Co3278 – St. Albans STP MVRT(2)

ADDENDUM #1

REVISED: Invitation for Bids and Proposal updated to reflect an estimate change, and updates to Plan Sheets 4, 8, 17, 24 and 26.

PROJECT NAME:	ST. ALBANS
PROJECT NUMBER:	STP MVRT(2)
FILE NAME: z24f026_pn.dgn	PLOT DATE: 6/30/2026
PROJECT LEADER: B.M. ROBERTS	DRAWN BY: R.M. O'BRIEN
DESIGNED BY: R.M. O'BRIEN	CHECKED BY: B.M. ROBERTS
GENERAL NOTES SHEET	SHEET 4 OF 62

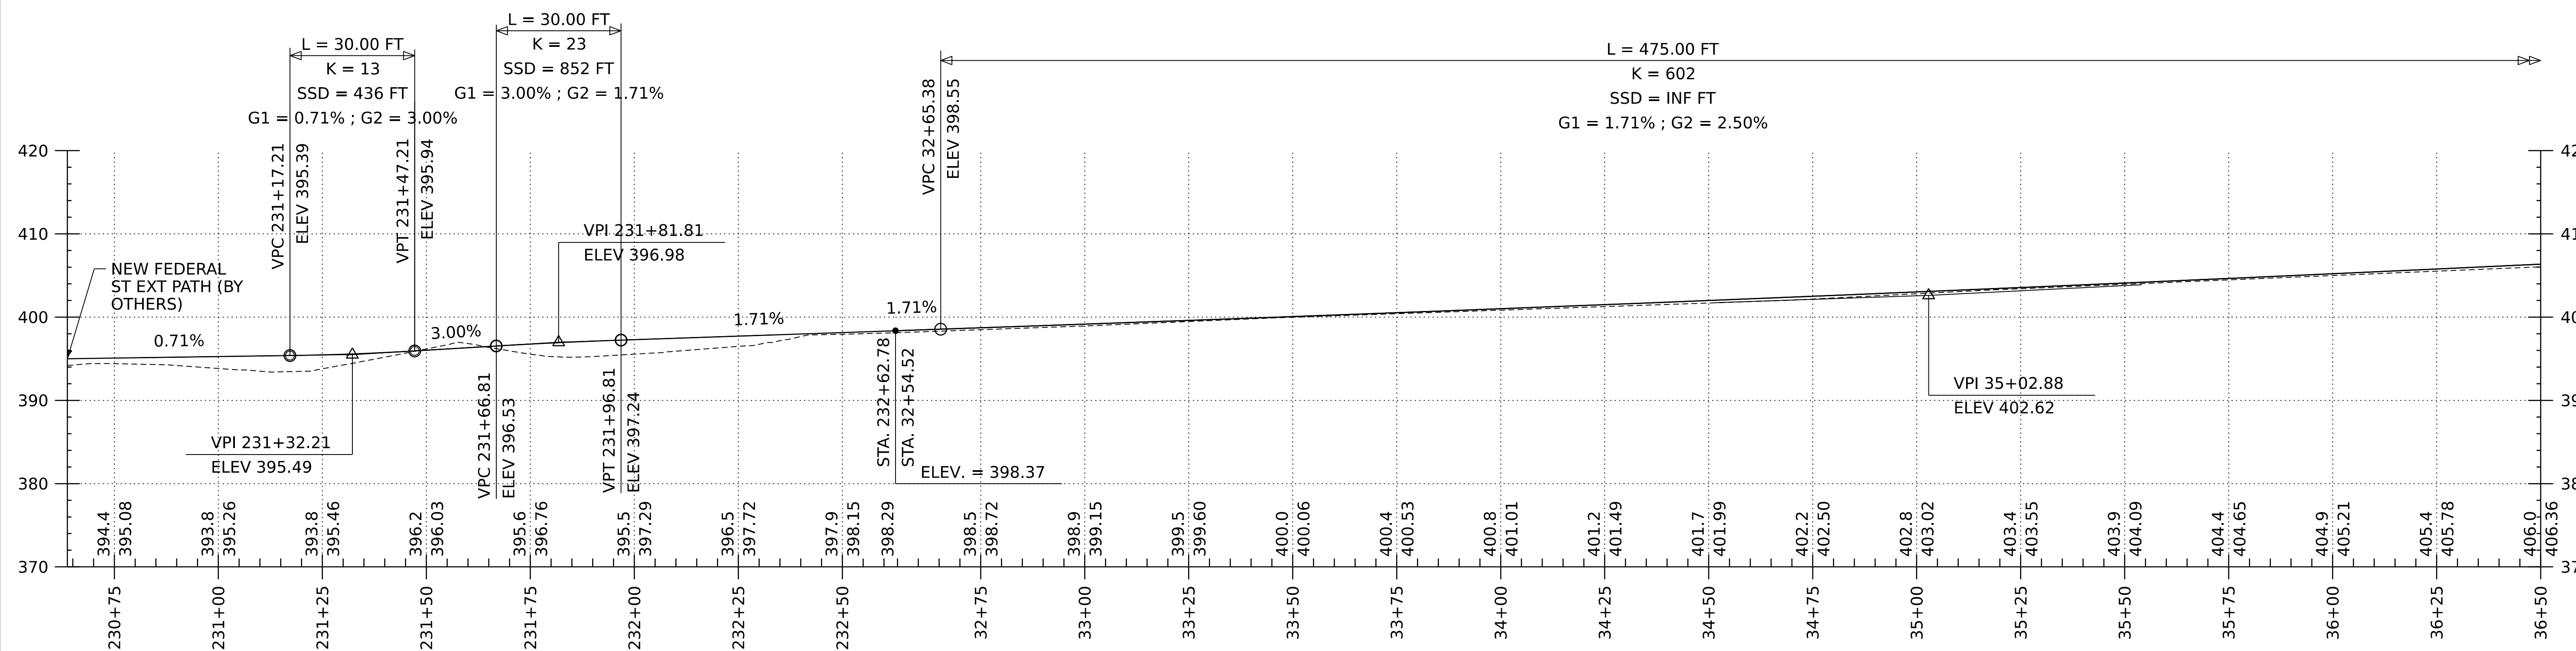
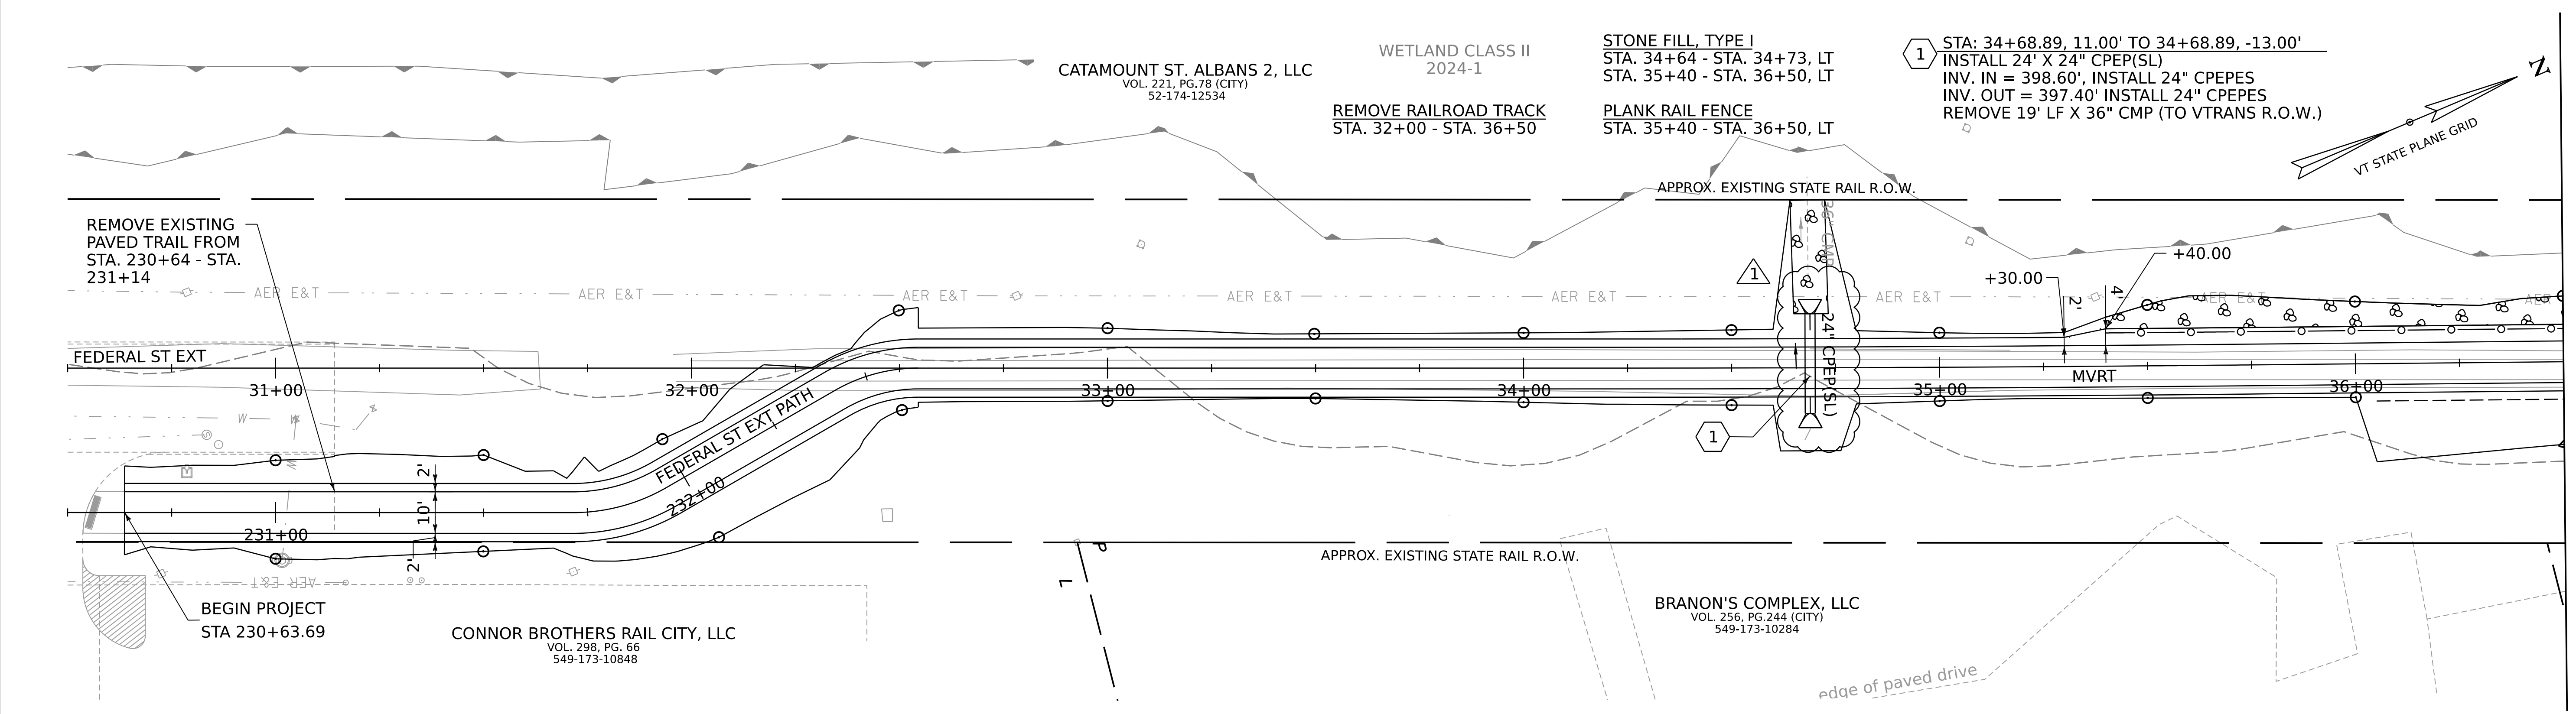
REV.	DATE	DESCRIPTION	BY
△1	06/30/2026	REVISED NOTE #9 LANGUAGE	VHB

THE RAILROAD TIE STOCKPILE AREA HAS TRAILSIDE AMENITIES AND A WOODEN FOOT BRIDGE OVER A DITCH. CONTRACTOR SHALL REMOVE AND SALVAGE THE TRAILSIDE AMENITIES TO AN EXISTING PARKING AREA NEAR THE SEYMOUR ROAD TRAIL CROSSING. ITEMS WILL BE RETRIEVED BY THE NORTHWEST REGIONAL PLANNING COMMISSION AND/OR THE CITY OF ST. ALBANS. THE WOODEN BRIDGE SHALL BE REMOVED AND DISPOSED OF BY THE CONTRACTOR. THE DITCHLINE SHALL BE RESTORED TO PROPER FUNCTION AS NEEDED FOLLOWING THE CONCLUSION OF STOCKPIILING ALL RAILROAD TIES. REMOVAL AND SALVAGE OF TRAILSIDE AMENITIES AND REMOVAL OF WOODEN FOOT BRIDGE SHALL BE PAID FOR UNDER ITEM 681.1020 "REMOVE LANDSCAPE ITEM." RESTORATION OF THE DITCH LINE AS NECESSARY SHALL BE CONSIDERED INCIDENTAL TO ITEM 201.1000 "CLEARING AND GRUBBING, INCLUDING INDIVIDUAL TREES AND STUMPS."
10.

FILE NAME: z24f026_bdr_pro_nu1.dgn
PROJECT LEADER: B.M. ROBERTS
DESIGNED BY: R.M. O'BRIEN
LAYOUT PLAN & PROFILE SHEETS (3 OF 5)

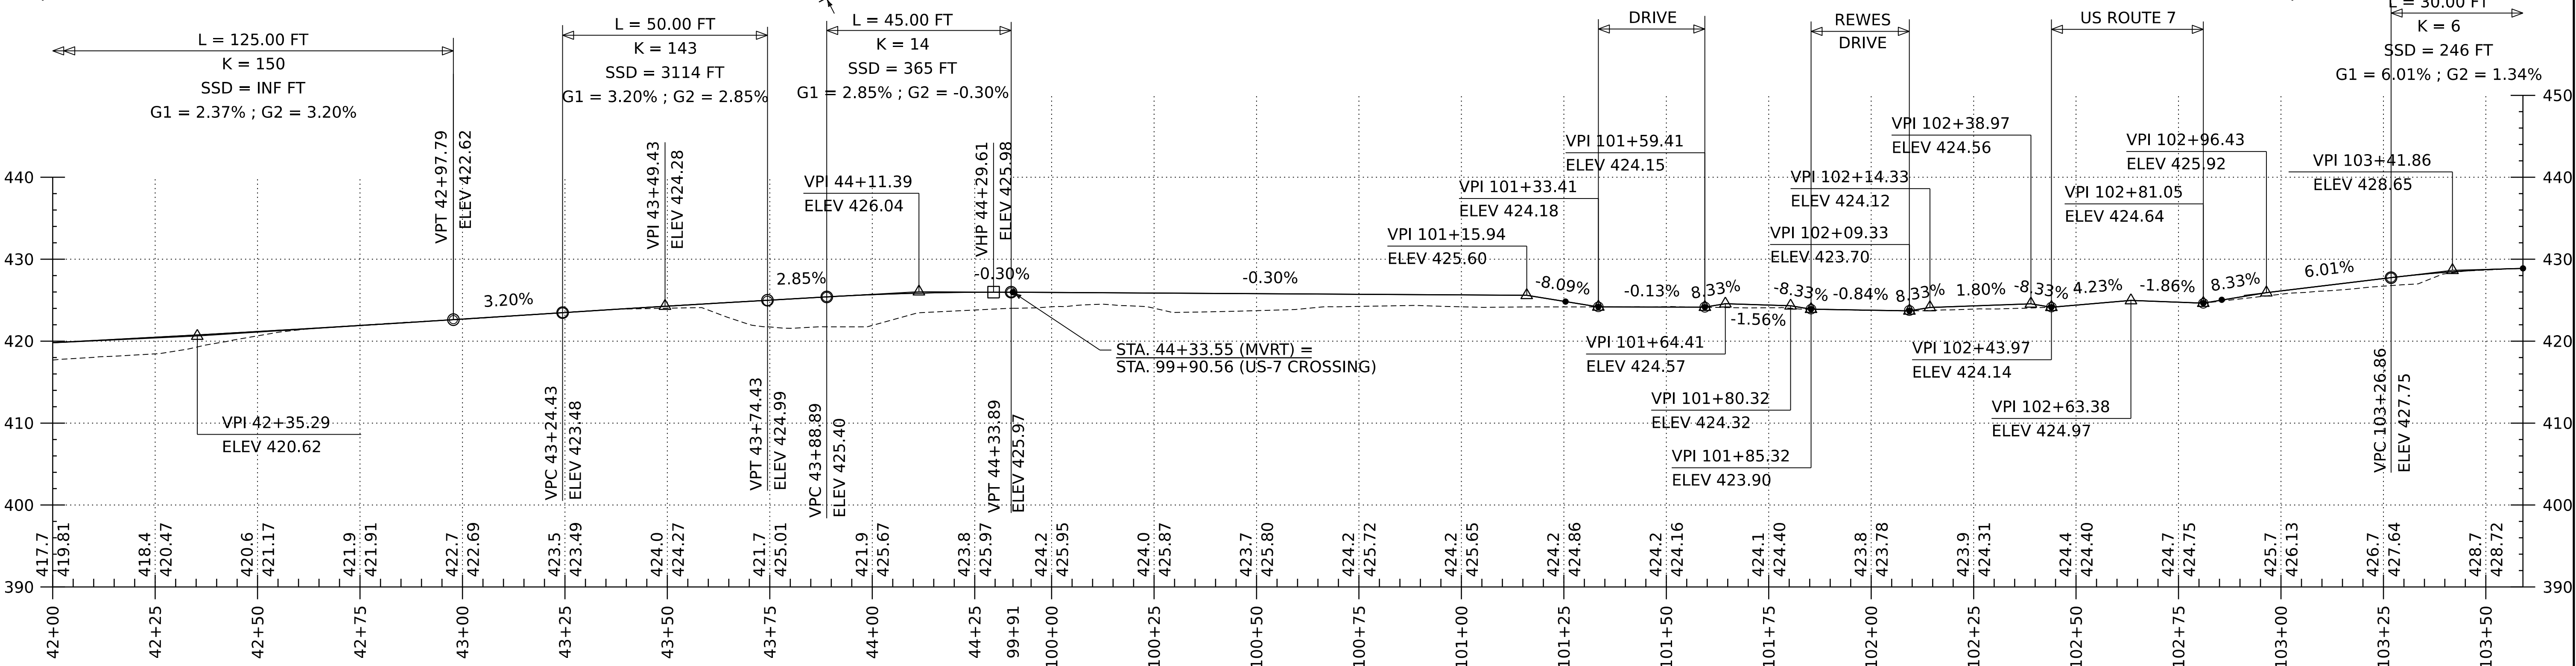
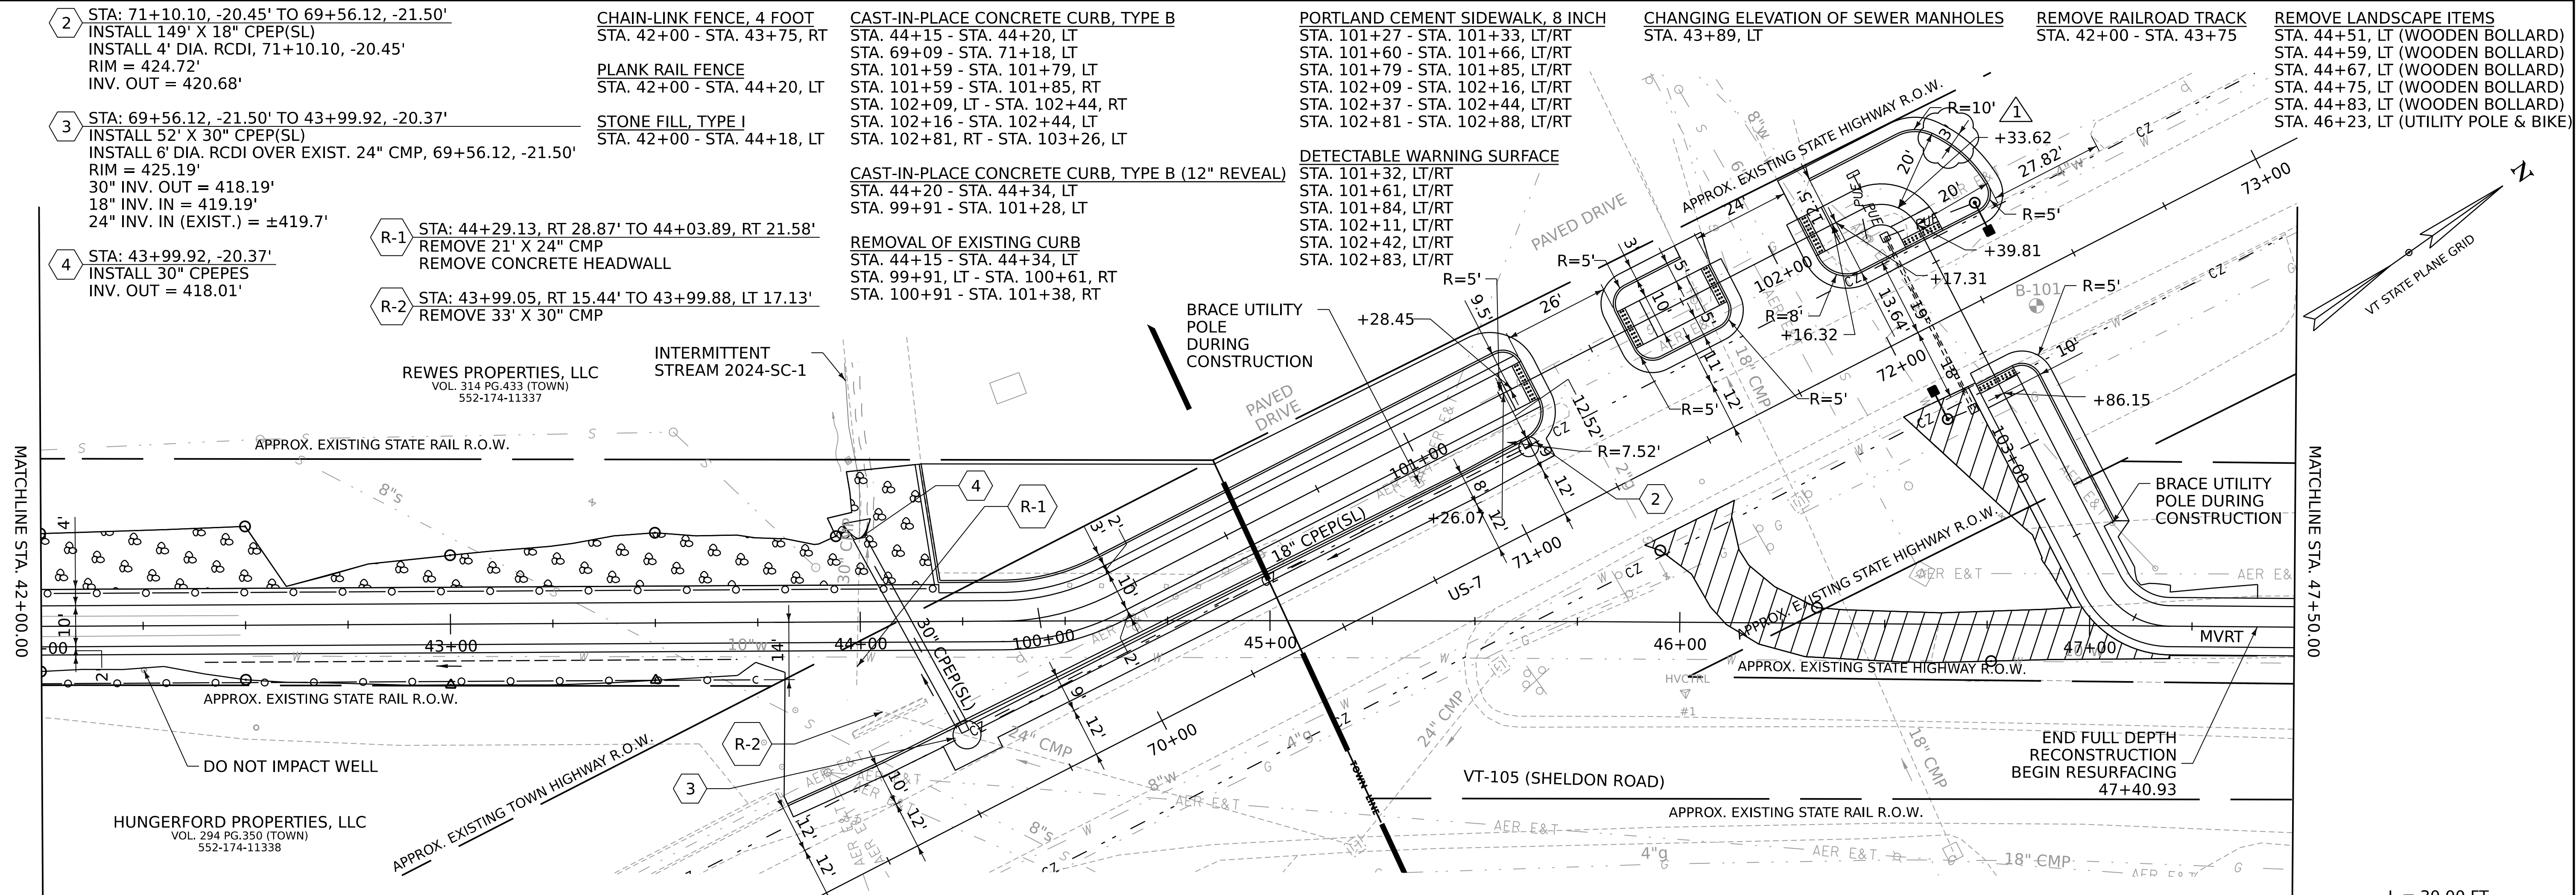
REV.	DATE	DESCRIPTION	BY
1	06/30/2026	ADD DIMENSION	VHB
